TOWN OF
BRECKENRIDGE

Planning Commission Meeting Agenda

Tuesday, October 2, 2018, 5:30 PM

1. Casey Residence (CK), 112 N. French Street, PL-2018-0262 28

SOUTH ELEVATION

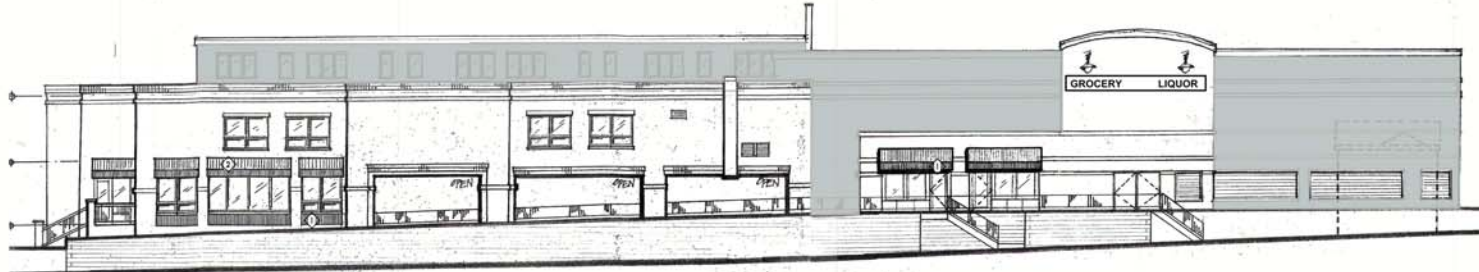
The applicant does not propose to increase the number of colors used, and staff finds that the proposed colors meet the chroma requirements of this Policy. Staff does not have any concerns regarding excessive dissimilarity, as the proposed modifications are not found by staff to further any non-conformity.

Staff has added a Condition of Approval that the applicant shall paint all exterior metal proposed with this project a flat, dark color or to match the building color, and that all exterior metal finished surfaces shall be non-reflective.

- Priority Design Standard 342: *“Avoid large blank wall surfaces that diminish pedestrian interest.* Considering the building does contain some existing larger walls without much glazing or diversity in façade material, staff supports the proposed materials, finding that the modifications will increase the visual interest of the building to the pedestrian.

- The labeling and notes provided have been updated to provide more clarity as to the scope of work proposed.
- The corrugated metal band has been removed from the plans, and the brick soldier course band on the upper portions of the building is proposed to remain.
- The awnings are no longer proposed to be raised (The plans show the awnings to be raised, but this is a drafting error, and the elevations drawings specify that there are not any awnings proposed to be raised.)
- All existing stucco, which is to be repainted, is shown in grey on the elevations.

SITE PLAN

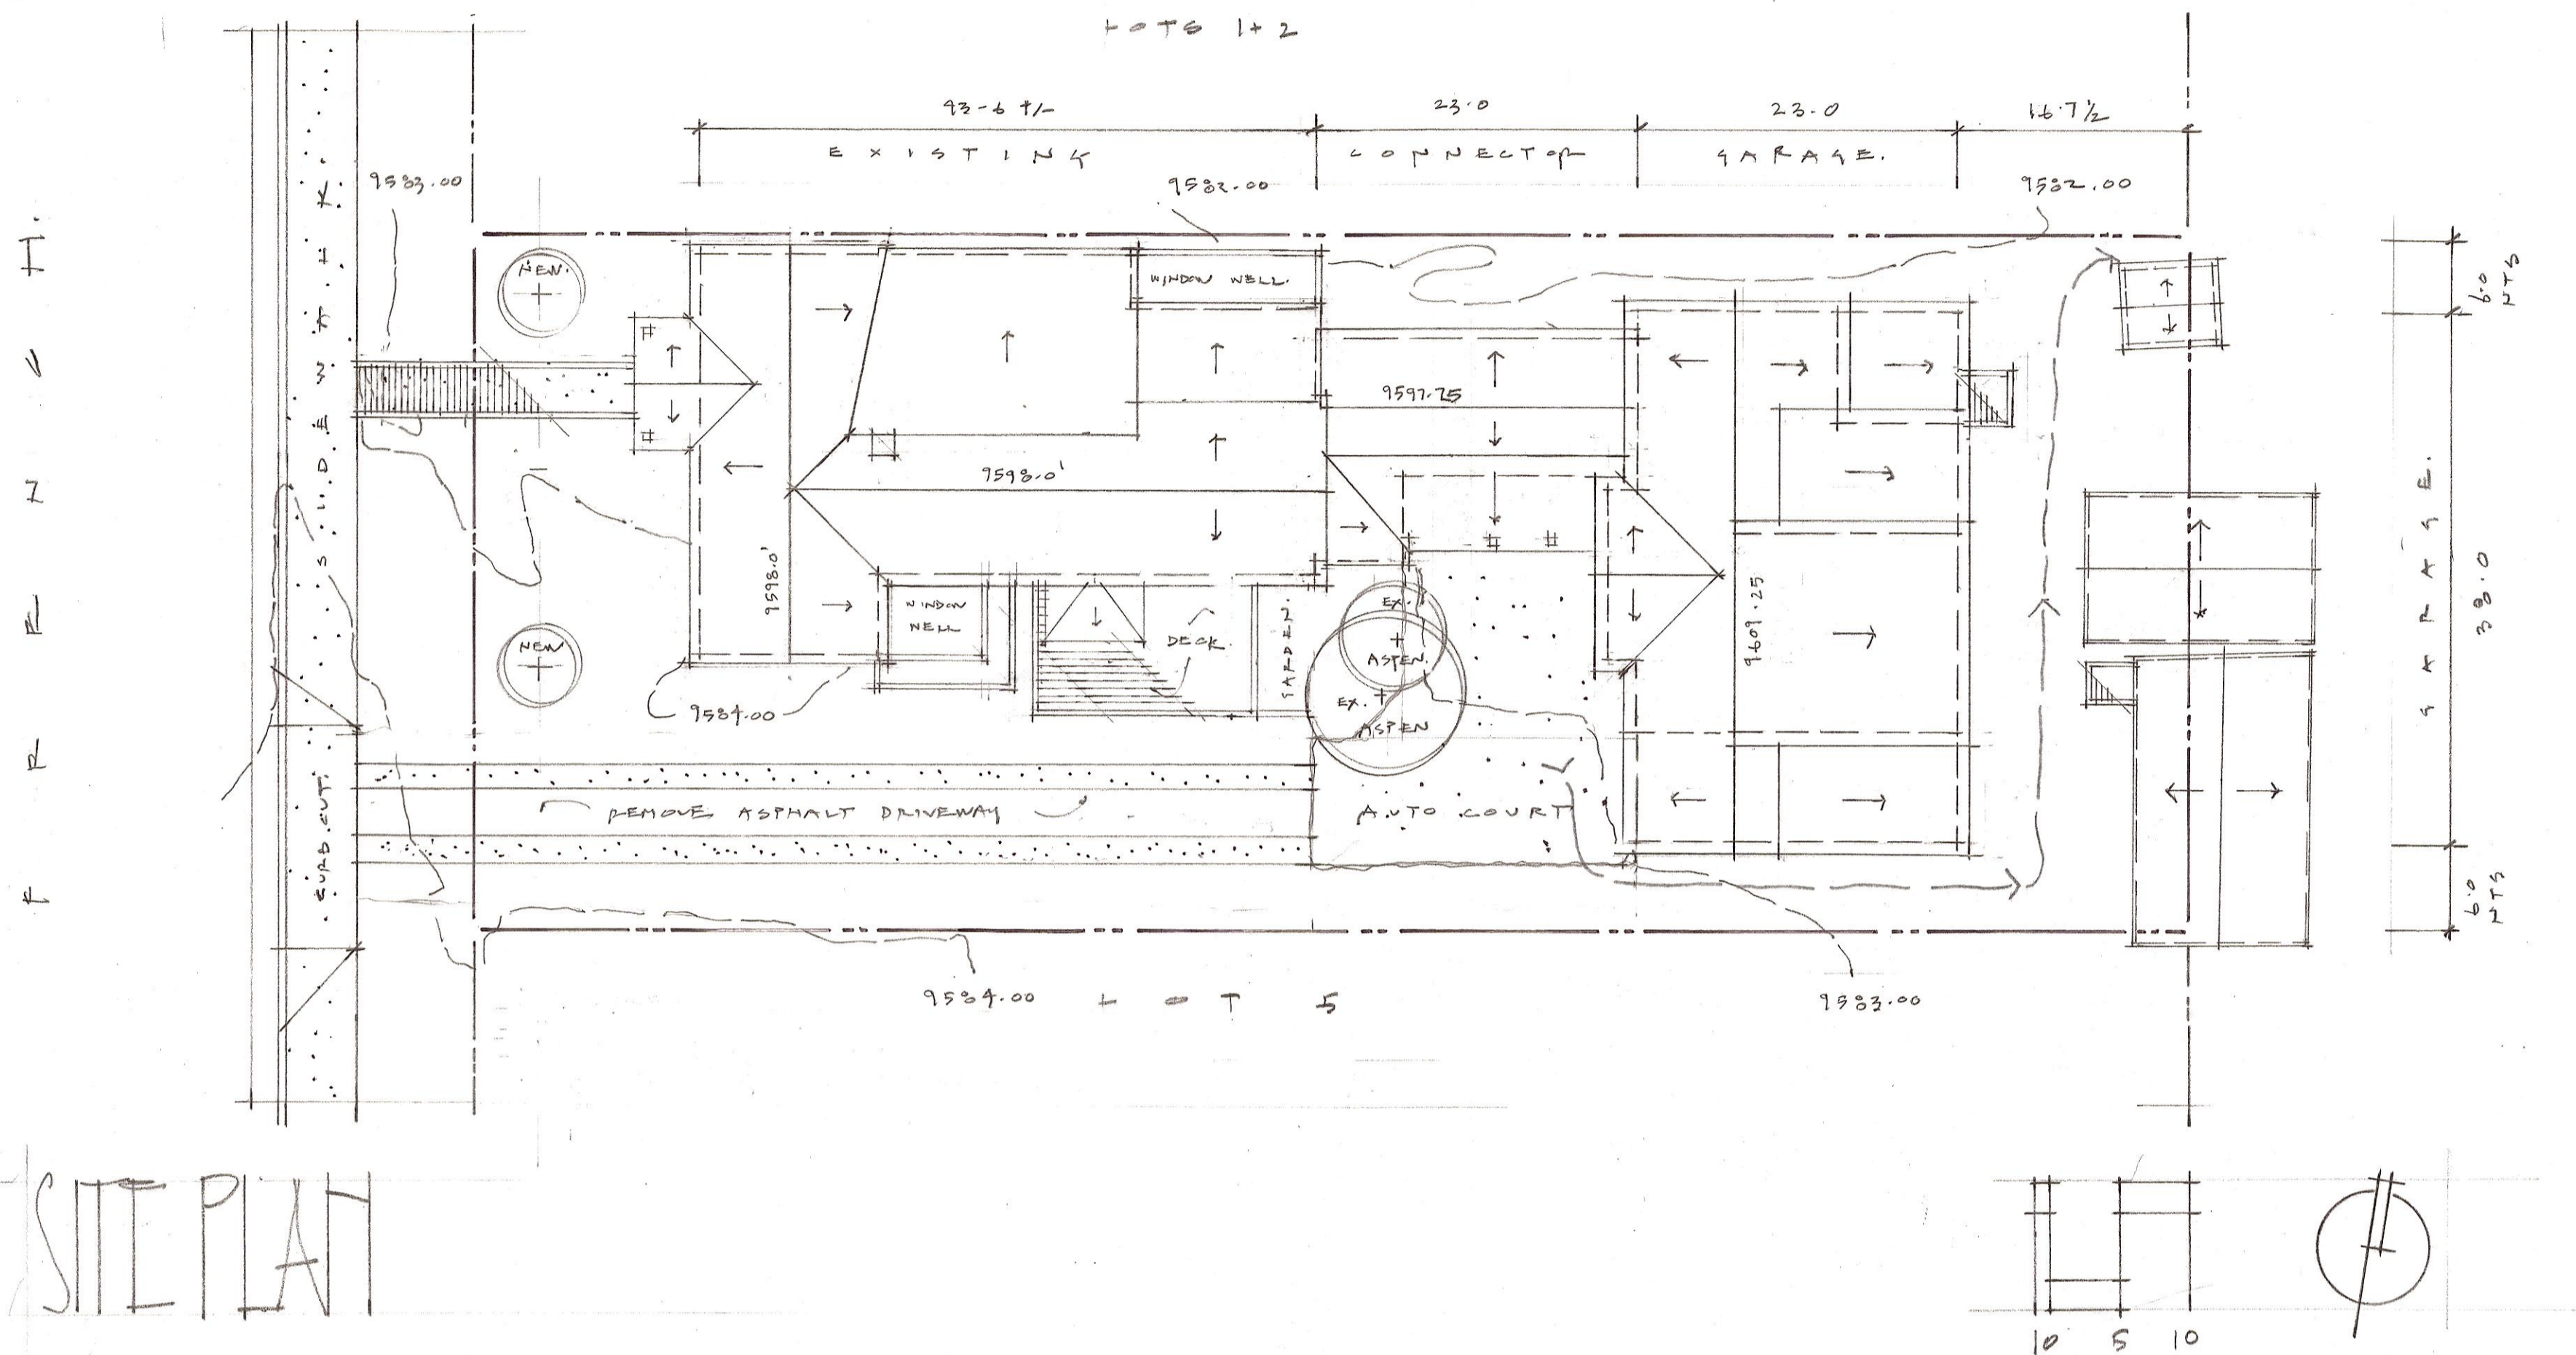
The property’s current driveway is up against the south property line, with no room for buffer or snow stacking. The proposed design shows the driveway being switched to paving strips and being pulled back 5’ from the south property line. This design now features enough room to add plantings or provide room for snow stacking. Typically, staff has required driveways to be a minimum of five feet (5’) from a property line and provide landscaping. Staff supports the revised driveway design.

Beyond the driveway design, the Commission expressed concern about the proposed addition’s proximity to the property line on both the north and south sides and the lack of landscaping on either side. Since the previous meeting, the applicants have increased the setbacks of the proposed addition and added nine aspen trees along the north and west property lines adjacent to the addition. The applicants

With the modifications to the driveway and added landscaping staff believes the revised design abides with Policy 7/R, Does the Commission concur?

LANDSCAPE PLAN

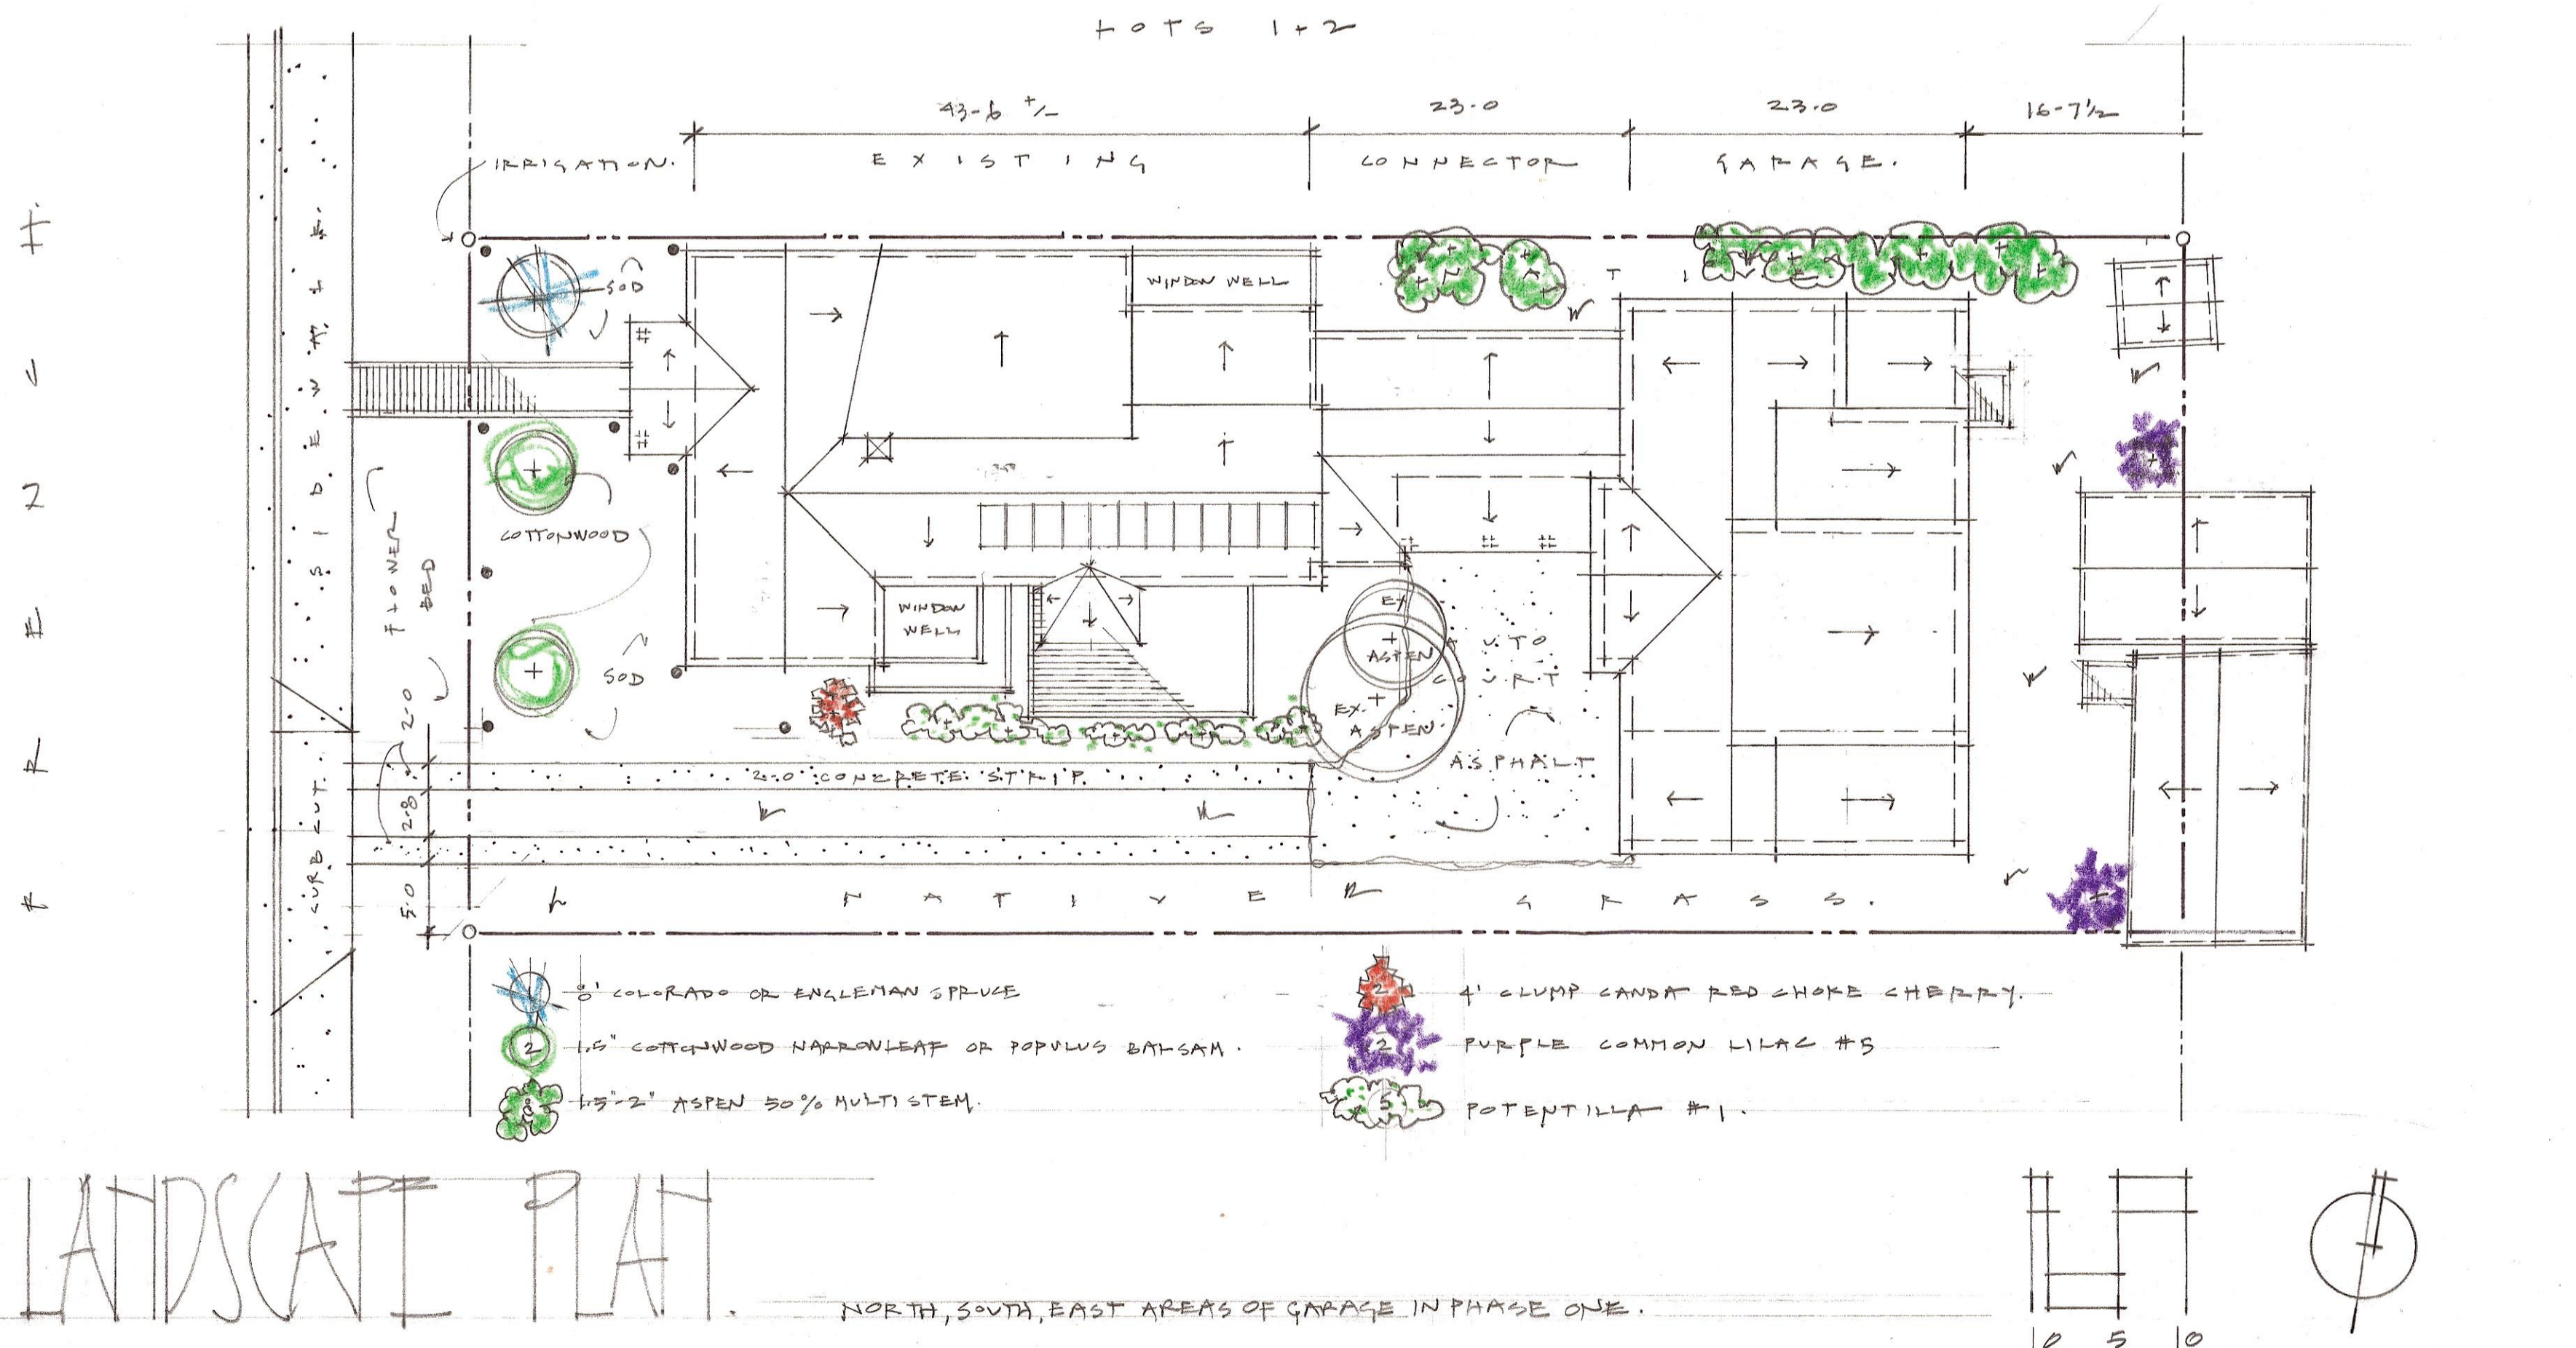
Plant Material & Landscaping (22/A & 22/R): The applicants show a landscape plan for the project, the proposed new plantings include two 3” caliper cottonwood trees and a 8’ Colorado or Engleman Spruce located in the front yard adjacent to North French Street, and twelve 2.5” caliper aspen trees, two purple lilacs, a 2-4’ clump of Canada Red Choke Cherry and 5 Potentillas on the remainder of the site. These plantings are designed to provide buffer from the street and neighboring properties. In addition to Policy 22/R, landscape design is reviewed in the Handbook of Design Standards.

The proposed landscape plan meets the requirement of “*at least one tree a minimum of eight feet (8') in height, or three inch (3) caliper, should be planted at least every fifteen feet (15') along all public rights of way adjacent to the property to be developed.*” With an evergreen tree and cottonwood trees in the front yard area, the design complies with Design Standards 131 and 132. The design is also compliant with Design Standard 133.

Based on past precedent, the landscape plan also exceeds the requirements of Policy 22/R. Staff recommends positive two (+2) points under Policy 22/R based on past precedent. Does the Commission concur?

- Provided a revised the landscape plan, the proposed new plantings include two 3" caliper cottonwood trees and a 8' Colorado or Engleman Spruce located in the front yard adjacent to North French Street, and twelve 2" caliper aspen trees, two purple lilacs, a 2-4' clump of Canada Red Choke Cherry and 5 Potentillas.
- The driveway design is revised and shows paving strips.
